**Environmental
Services, Inc.**

RE: Addendum to Work Plan for Site Characterization
2926 - 2942 San Pablo Avenue (Fuel Leak Case No. RO0002567)
Oakland, CA

Thank you for your prompt review of the above-referenced work plan. This addendum addresses those items listed in your review letter of March 31, 2004.

FIGURE 5
PROPOSED BORINGS - ON SITE

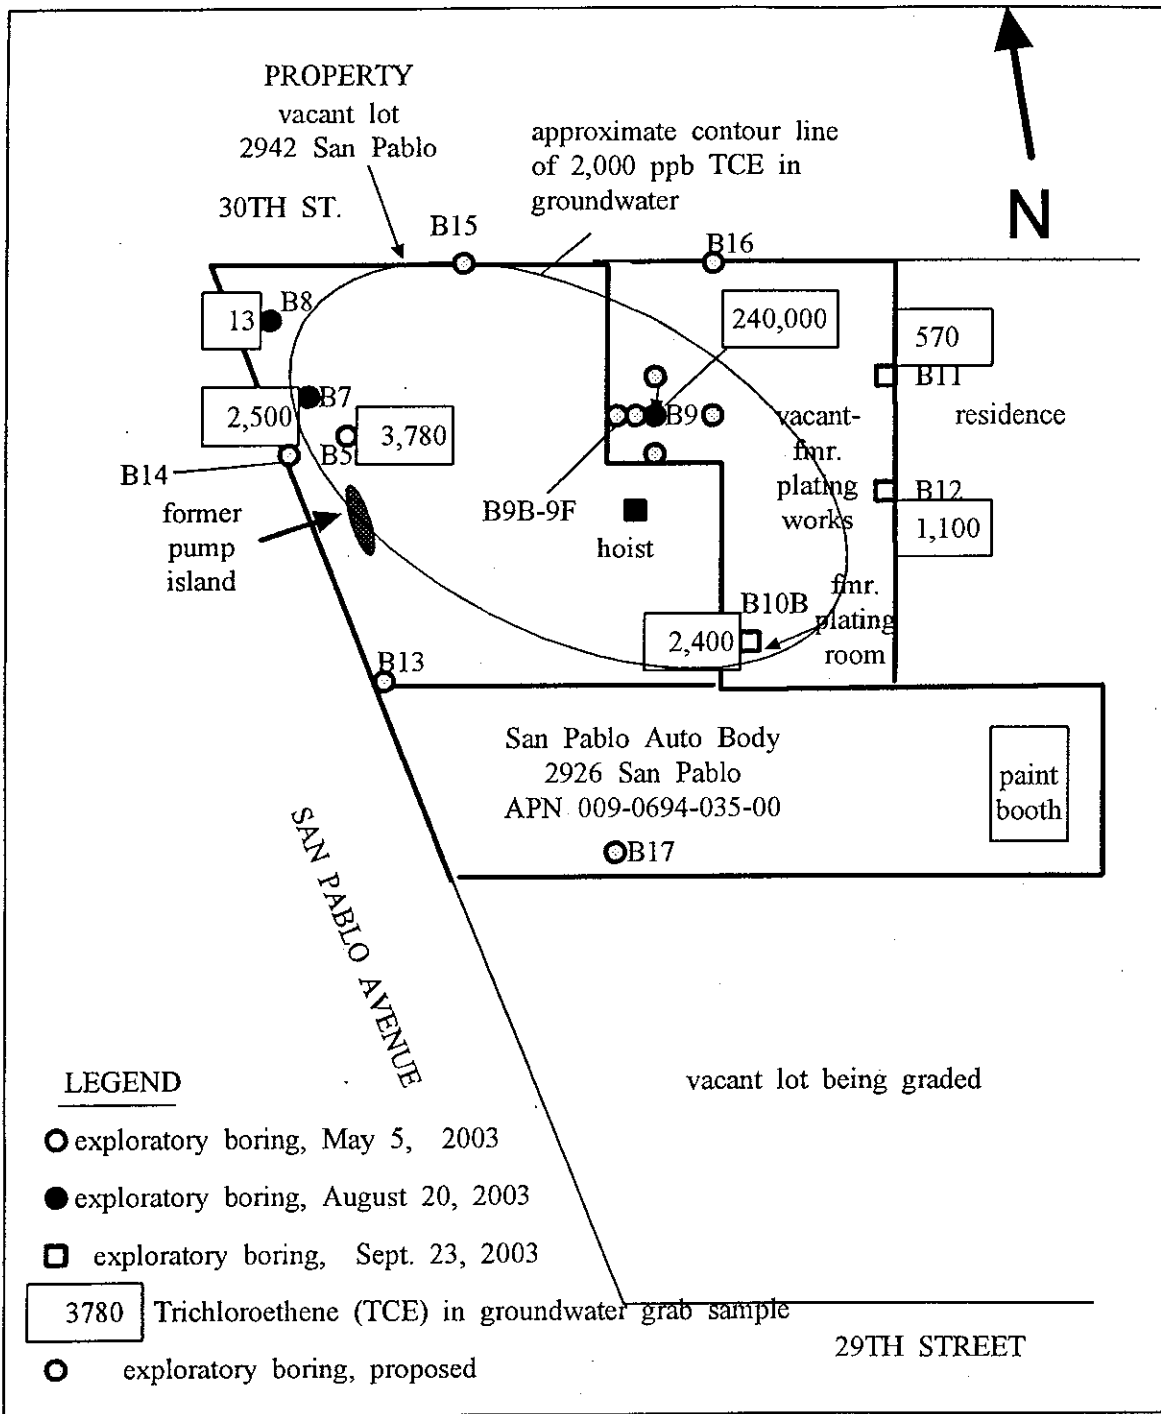
Per your request, additional borings to the north and south are proposed. B16, as shown on the revised Figure 5, is to be located along the northern perimeter of the Property. B17 is located along the southern perimeter of the Property, within the auto body shop.

At your recommendation, offsite delineation by previously proposed borings B16 through B18 will not be pursued at this time.
